**RE: Carrington Road Improvements and Point Chevalier Watermain No. 2 Project – Responses to requests for further information (BUN60444262 / LUC60444264 / WAT60444263)**

**To:** Auckland Council  
**From:** Carrington Road Improvements Project Team  
**Copy:** Kelly Durham, Auckland Transport  
**Subject:** Attachment A – Technical Memorandum – Airing Court Wall further assessment

**To:** Auckland Council  
**From:** Carrington Road Improvements Project Team  
**Copy:** Kelly Durham, Auckland Transport  
**Subject:** Attachment B: Technical Memorandum – Deletion of Mt Albert pedestrian bridge

Figure 1 – Eastward lateral shift required to avoid the wall

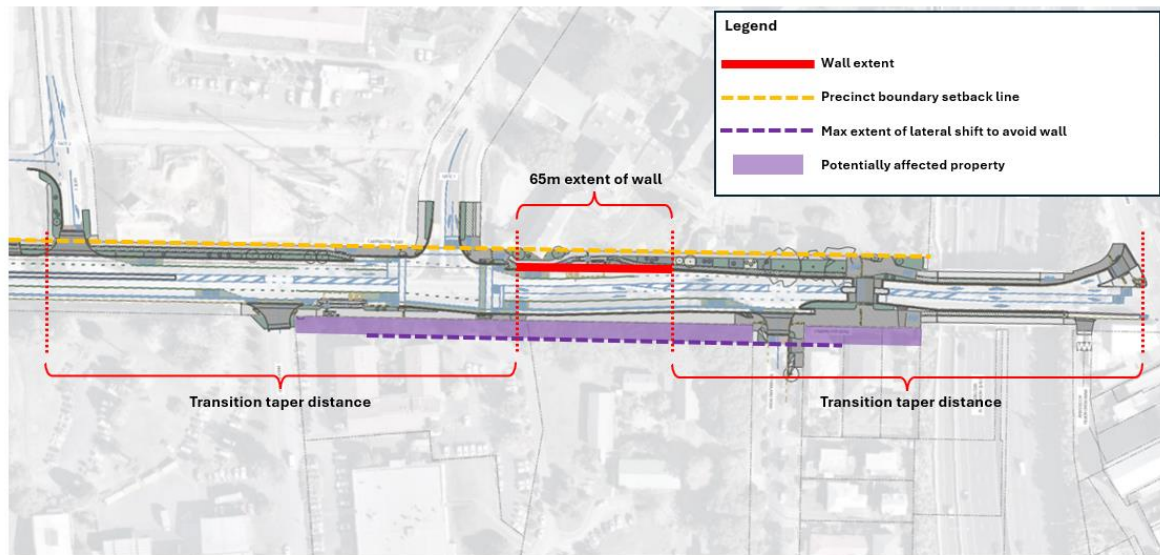
The memorandum addresses items 23 and 28 of the s92 request which in short seek clarification on the assessment substantiating the need to remove the wall. Specifically:

- Whether an option to realign Carrington Road eastwards to avoid the wall has been assessed;
- Whether an option to further narrow the proposed Carrington Road cross-section to avoid the wall has been assessed;
- Whether assessment of the above options has given adequate weight to the heritage value of the wall; and
- By extension, whether the proposed removal of the wall is justified.

To avoid the wall through further localised realignment of the corridor to the east (i.e. without further reduction of the corridor width), the following design parameters would need to be adopted:

- A lateral shift of 8m to the east of the centreline for adjoining sections to the north and south (i.e. a further 5.7m over and above the 2.3m already adopted). This lateral shift would need to clear the 65m length of the wall, before transitioning back to the remainder of the alignment via tapers to north and south.

The option of further localised realignment of the corridor as described above is acknowledged to have heritage benefits insofar as it achieves avoidance of the wall. However, the option introduces significant design constraints and additional adverse effects, which are described in further detail below.

As noted above, achieving the lateral shift of 8m to the east needed to clear the wall requires a transition taper distance of approximately 185m to tie back into the remainder of the alignment to the north and south to achieve compliance with the relevant geometric design standards.

To the north, the alignment must tie into the existing SH16 bridge as a fixed constraint – a new bridge or substantial modifications to the existing bridge are not within the Project scope. The location of the bridge is such that it only allows for a 100m transition taper, meaning that a compliant tie-in would not be possible.

For the reasons discussed at 3.1.2 above, Option 1 was discarded despite enabling avoidance of the wall.

Currently proposed cross-section at Mt Albert Rail Bridge

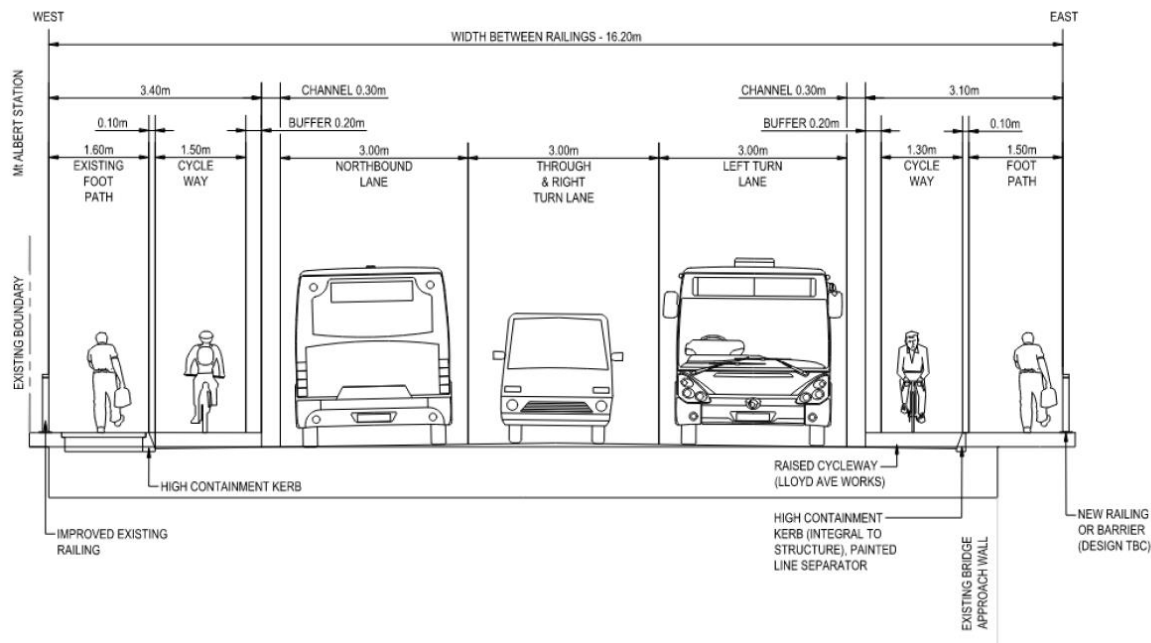
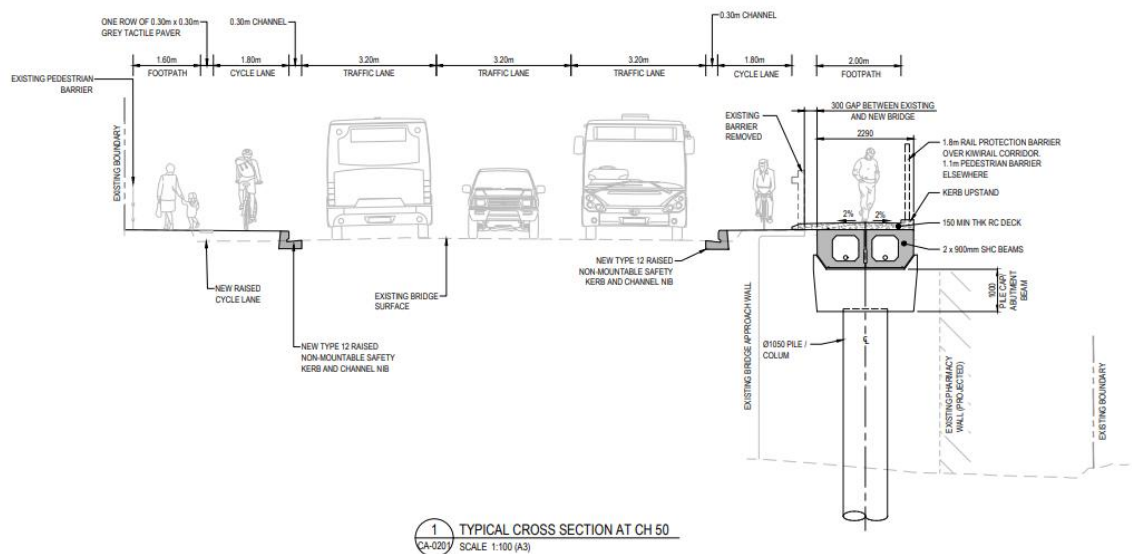
This technical memorandum summarises a proposed change to the design of the Carrington Road Improvements Project – namely the deletion of the previously proposed pedestrian bridge adjacent to the Mt Albert Rail Bridge. The design change will result in a generally **reduced** level of adverse effects.

Since the Preliminary Design, Auckland Transport has taken the decision to delete the previously proposed pedestrian bridge from the Project. Instead, it is now proposed that works in this location

are limited to improvements to the existing Mt Albert Rail Bridge within the existing 16.2m width as follows:

- Maintaining the existing active mode facilities on the eastern side of the bridge, which were recently upgraded as part of works associated with the Lloyd Avenue level crossing closure. The facilities comprise a 1.5m footpath and 1.3m cycle lane with 0.1m marked horizontal separation between them, 0.2m horizontal separation from the carriageway, and with cycle lane raised to be flush with the footpath;
- Western cycle lane to be widened to 1.5m, and raised to be flush with the footpath to match the recently upgraded eastern side of the road (and removal of existing separators);
- New kerb and channel on the western side to match the recently upgraded eastern side of the road;
- New eastern railing/barrier, and improvements to the existing western railing; and
- A reduction of 0.2m in the carriageway width to accommodate the above improvements.

These changes are illustrated in the attached cross-sections (see **Attachment 1**).

The design change has been endorsed by Auckland Transport's Project Control Group, and was the subject of a workshop with the Albert-Eden Local Board on 5 June 2025. The rationale for the change is as follows:

- Significantly reduced construction risks and disruption;
- Lower carbon footprint;
- Requires no utility relocation in this location;
- No property impact or acquisition required;
- Increases the benefit-cost ratio of the Project to over 5 while providing similar benefits;
- Provides a marginal safety improvement compared with existing;
- Is a value-engineered solution with costs well within the available funding envelope; and
- Is supported by Auckland Transport Subject Matter Experts.
